ADMINISTRATIVE AMENDMENT
LEE COUNTY, FLORIDA

WHEREAS, Heritage Naples Acquisition, Inc. represented by Planning Development Inc. filed an application for administrative approval to a Residential Planned Development on a project known as Coconut Shores f/k/a Woodside Lakes in order to achieve the changes to the Master Concept Plan and add deviations described in Attachment B for property located at 3250 Coconut Road, Bonita Springs, described more particularly as:

NOW, THEREFORE, IT IS HEREBY DETERMINED that the application for administrative approval for an amendment to Residential Planned Development is **APPROVED.**

1. **The Development must be in compliance with the approved four-page Site Plan consisting of the amended 3-page Master Concept Plan (Pages 1 and 2 of 3 stamped received June 16, 1998 and Page 3 of 3 stamped received July 2, 1998) and Landscape Concept Plan (stamped received June 16, 1998). Site Plan PD-98-032 is hereby APPROVED and adopted. A reduced copy is attached hereto as Attachment A.**

APPROVED
Amendment to Master Concept Plan
(K) Subject to conditions in Resolution PD-98-039
Zoning Case #95-10-026.13A 02.01
Date July 9, 1998
Page 1 of 3

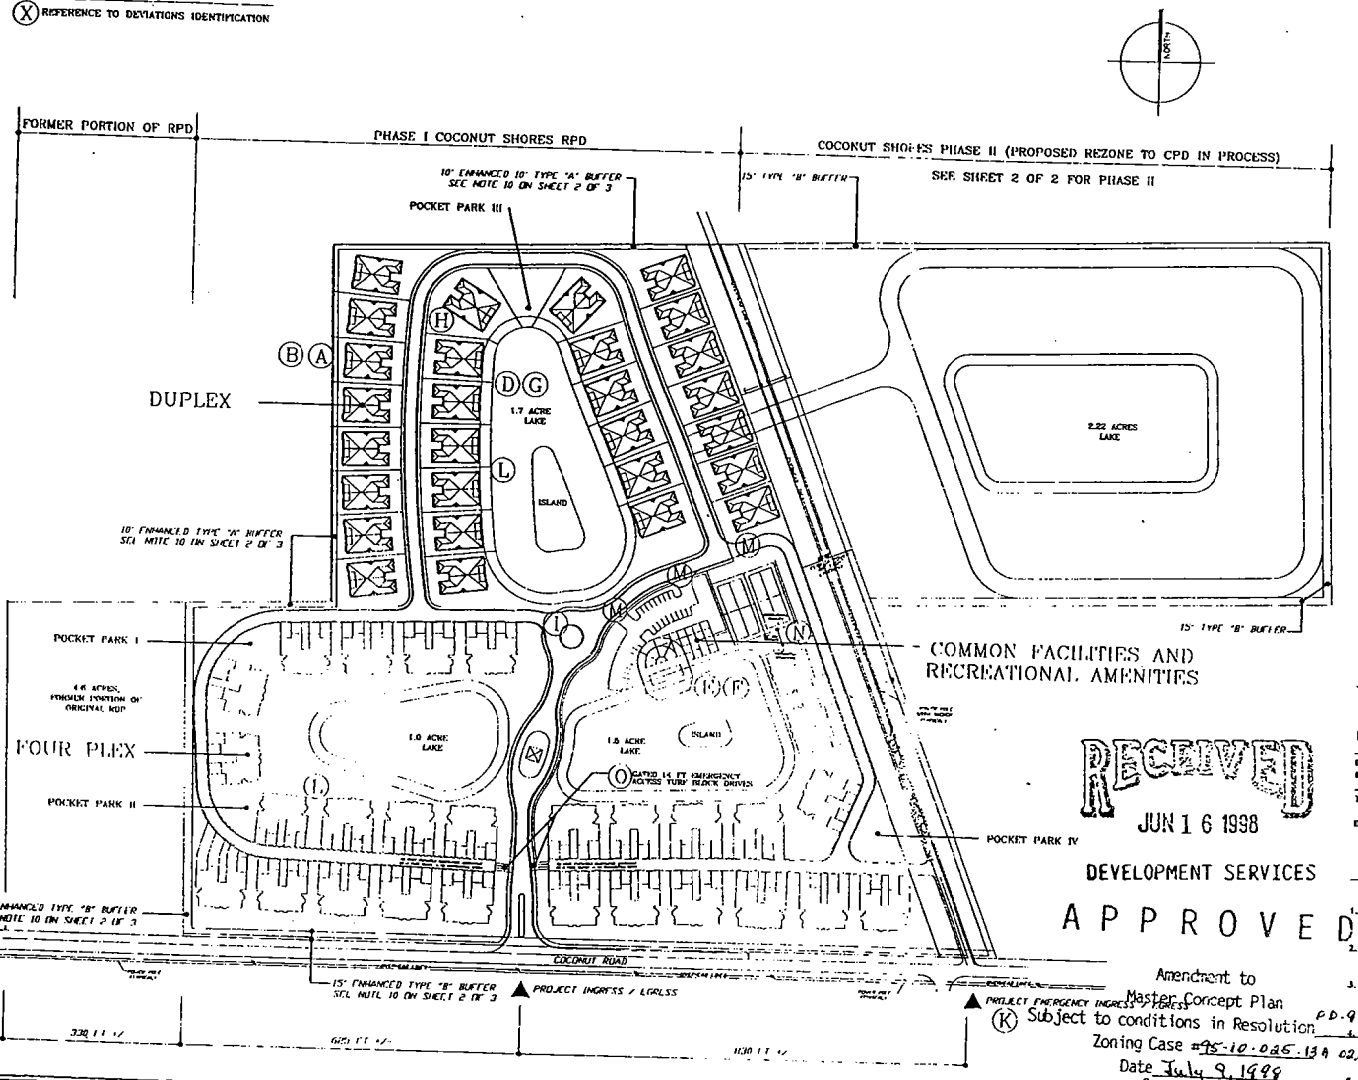
WHEREAS, the proposed changes include a change to duplex and four-plex (multiple family) dwelling units, redesignate the approved open space within the project, and anticipate the removal of the portion of the approved RPD located east of the Florida Power and Light easement from the project; and

Deviation (M)	Relief from LDC Section 10-285(a)Table 1. Which Requires a Connection Separation of 125 Feet to Allow Two Driveways from the Recreational Parking Lot and One from the Eastern Four-plex Neighborhood as Graphically Shown On Sheet 1 of 3.
Deviation (N)	Relief from LDC Section 34-2474(b)(6) Which Requires Recreational Facilities Maintain a Minimum Setback of 40 Feet from Any Residential Structure to Allow a Setback of 25 Feet.
Deviation (O)	Relief from LDC Section 10-296(m)(4)a. Which Limits Privately Maintained Accessways to 50 or Fewer Multi-family Residential Units to Allow a Maximum of 60 Units as Graphically Depicted on Sheet 1 of 3; as shown with Estero Fire Department Approved Gated Access Drives.

LANDSCAPE CONCEPT PLAN
COCONUT SHORES

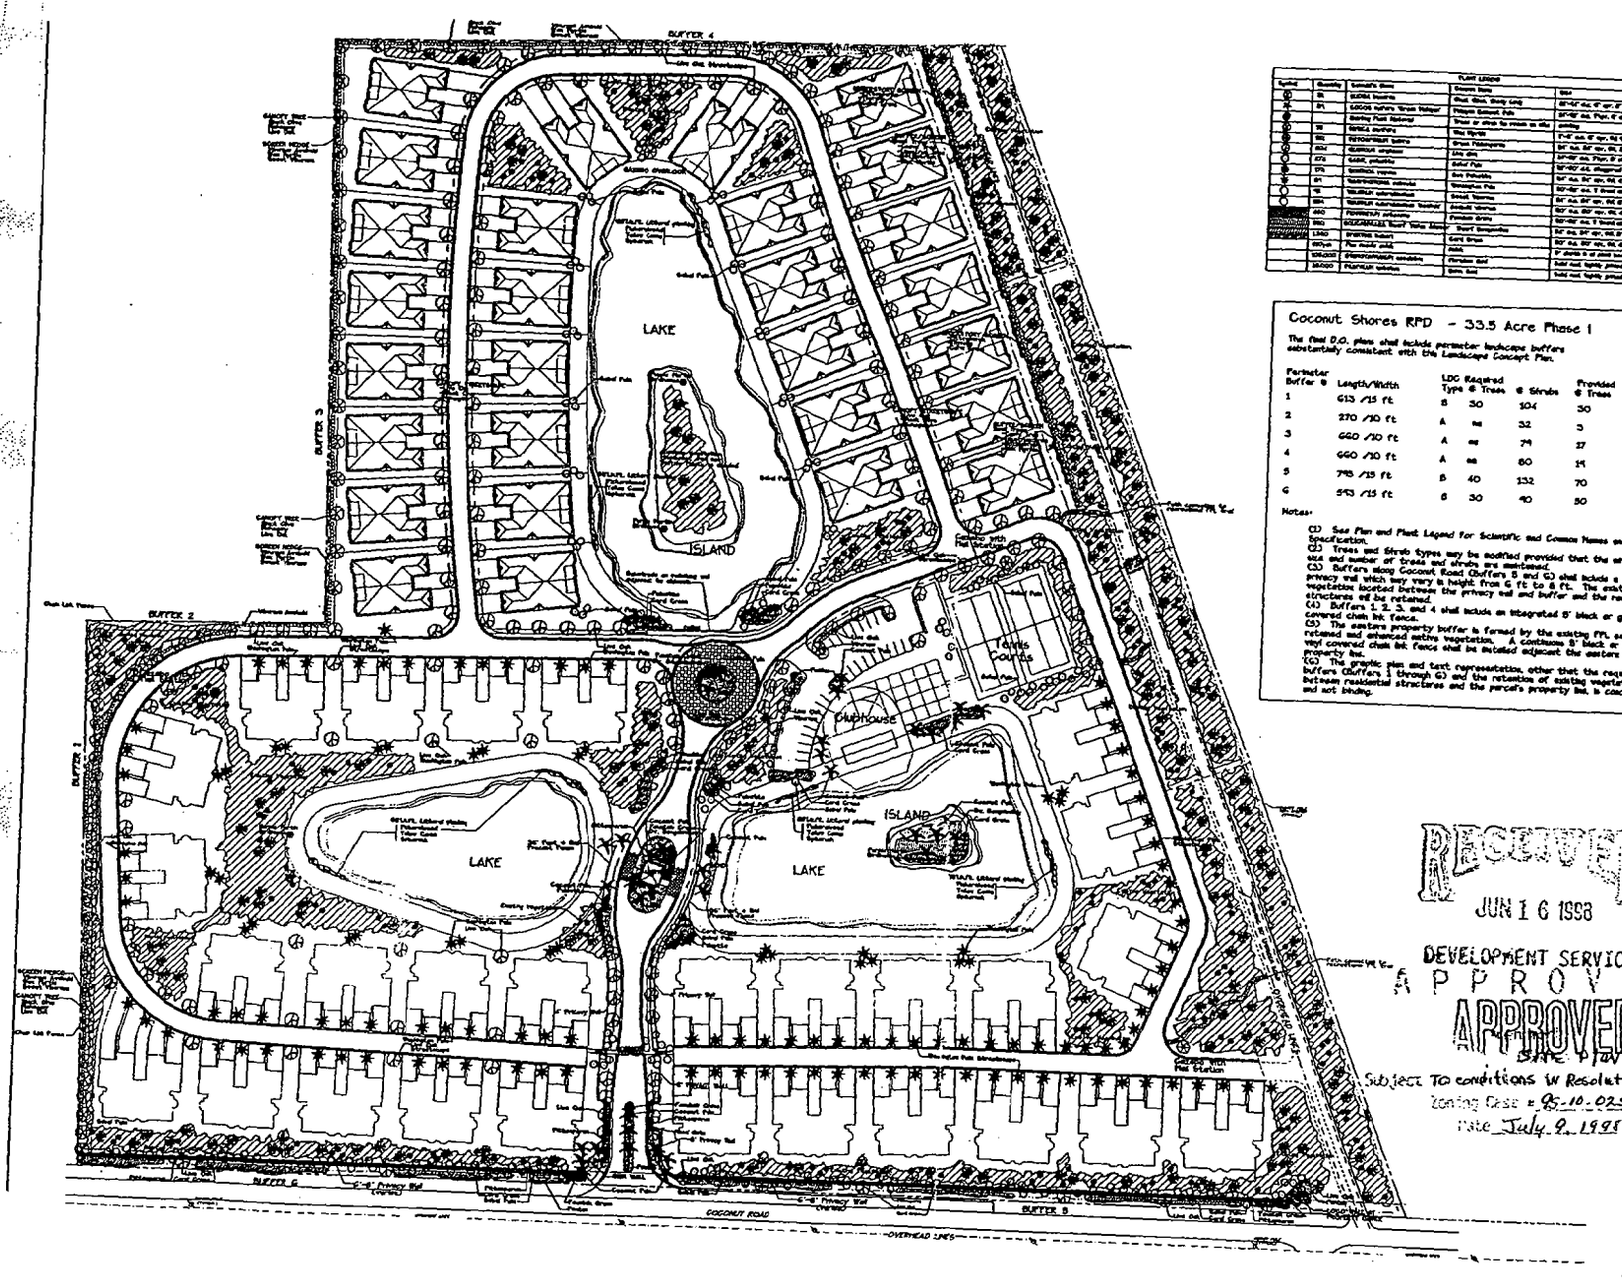
(3) Buffers along Coconut Road (Buffers 5 and 6) shall include a continuous privacy wall which may vary in height from 6 ft to 8 ft. The existing vegetation located between the privacy wall and buffer and the residential structures will be retained.

(4) Buffers 1, 2, 3, and 4 shall include an integrated 6' black or green vinyl covered chain link fence.
(5) The eastern property buffer is formed by the existing FPL easement and its required and enhanced native vegetation. A continuous 6' black or green vinyl covered chain link fence shall be located adjacent the eastern property line.

WHEREAS, the 6 to 8 foot privacy wall with landscaping on both sides provides buffering substantially equal to the 75 foot wide green space/future road right-of-way originally approved along Coconut Road; and

The final D.O. plans shall include perimeter landscape buffers substantially consistent with the Landscaped Concept Plan.
